## REMARKS

This application has been reviewed in light of the Office Action dated January 10, 2003. Claims 1-3 and 5-27 are pending in this application, with Claims 1, 8, 16, 19, and 22 in independent form. Claim 4 has been cancelled, without prejudice or disclaimer of the subject matter presented therein. Claims 1, 8, 16, and 26 have been amended to define more clearly what Applicants regard as their invention. Applicants note that the changes to Claims 16 and 26 affect matters of form only and do not, in any way, narrow the scope of either of these claims. Favorable reconsideration is requested.

**FIG. 15**

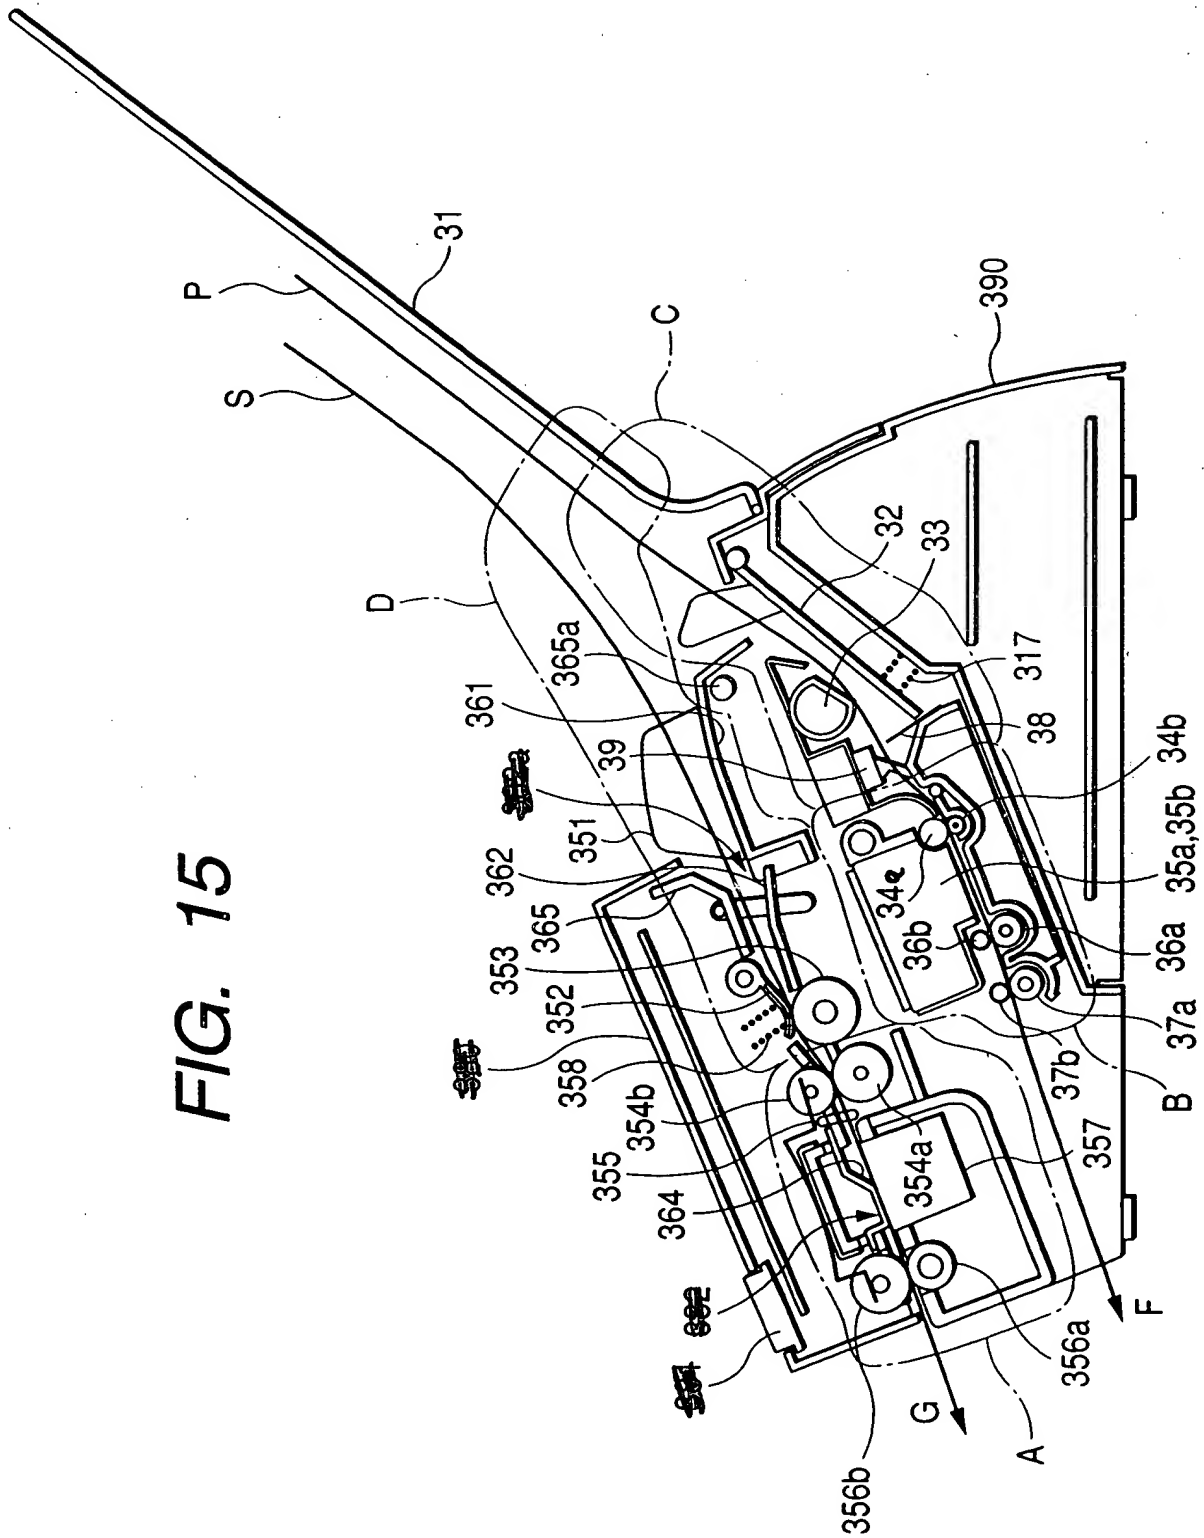
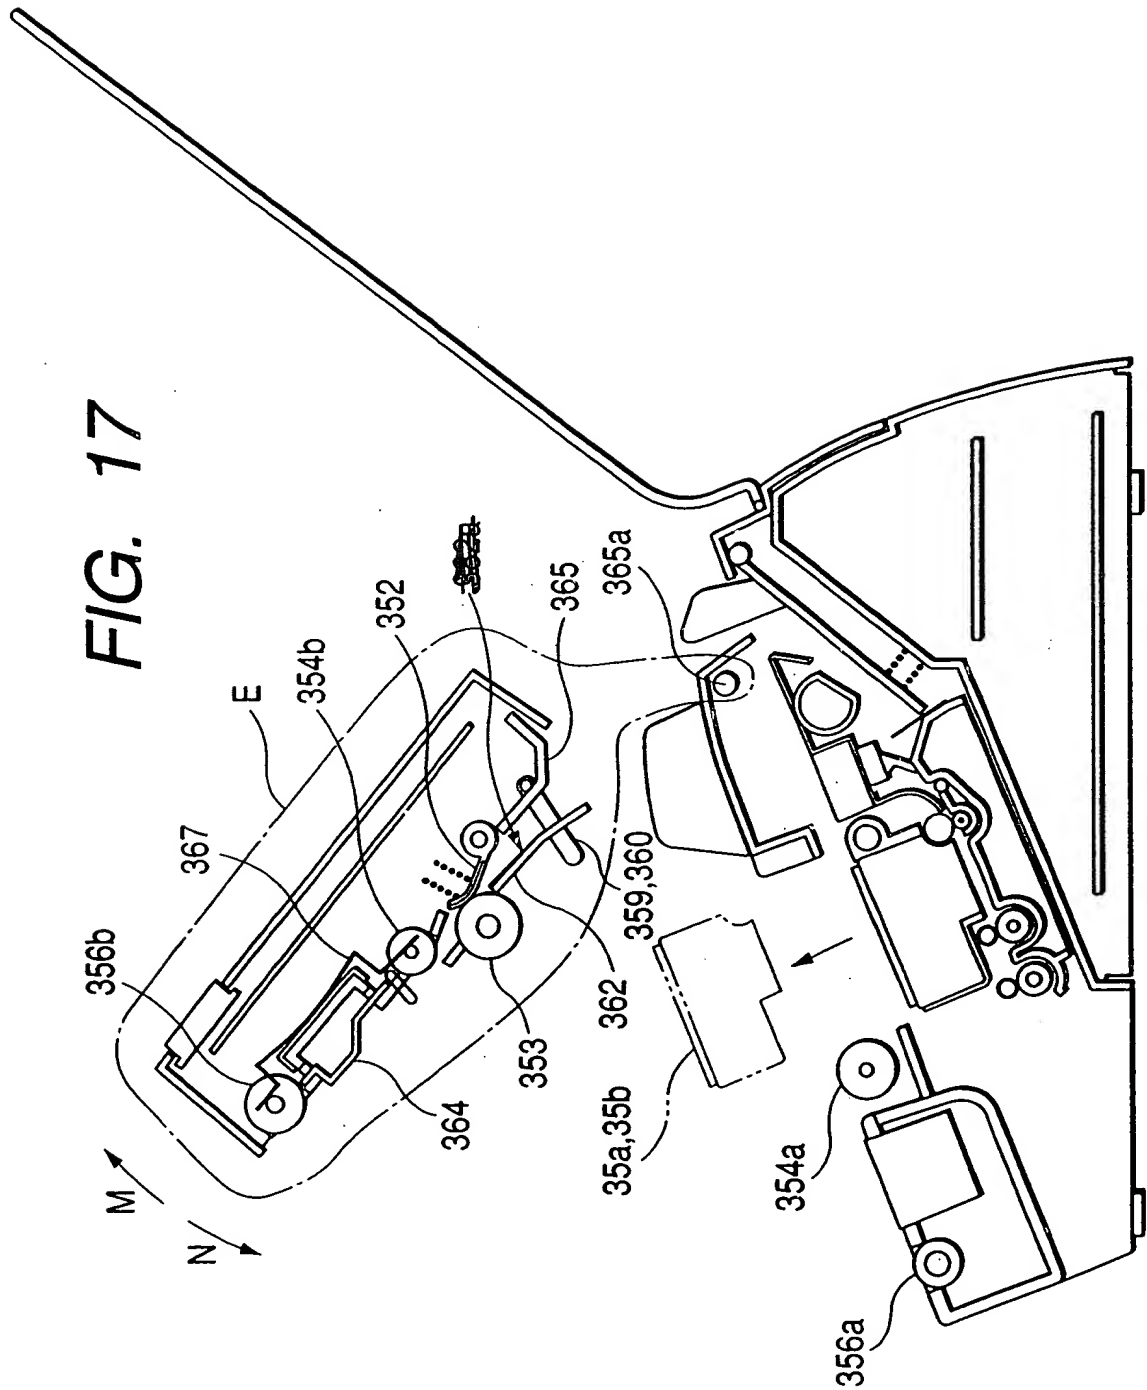
The Office Action also includes a set of objections to the drawings under 37 C.F.R. § 1.84(p)(5), for allegedly including reference numerals mentioned in the specification, but not shown in the drawings. With the exception of reference numerals 14, 21b, 428, and 1104a, all of the reference numerals, listed in the top half of paragraph 3 of the Office Action, were found in the figures. For reference numeral 14, Applicants have amended page 54, line 9 of the specification to read --the reading sensor 214--, instead of “a reading sensor 14.” Reading sensor 214 can be found in Figure 10. In regard to reference numeral 21b, Applicants have amended page 62, line 6, to read --feeding roller 211b--, instead of “feeding roller 21b.” Feeding roller 211b is shown in Figure 10. For reference numeral 428, Applicants have amended page 88, line 20, to read --Numeral 426 denotes a sensor for detecting the tip end of the recording sheet--, instead of “Numeral 428 denotes a sensor for detecting the tip end of the recording sheet.” Sensor 426 can be found in Figures 22 and 23. Finally, in regard to reference numeral 1104a, Applicants are amending Figure 37 to include this reference numeral.

351: Figure 15, top

353: Figure 15, top

361: Figure 15, top
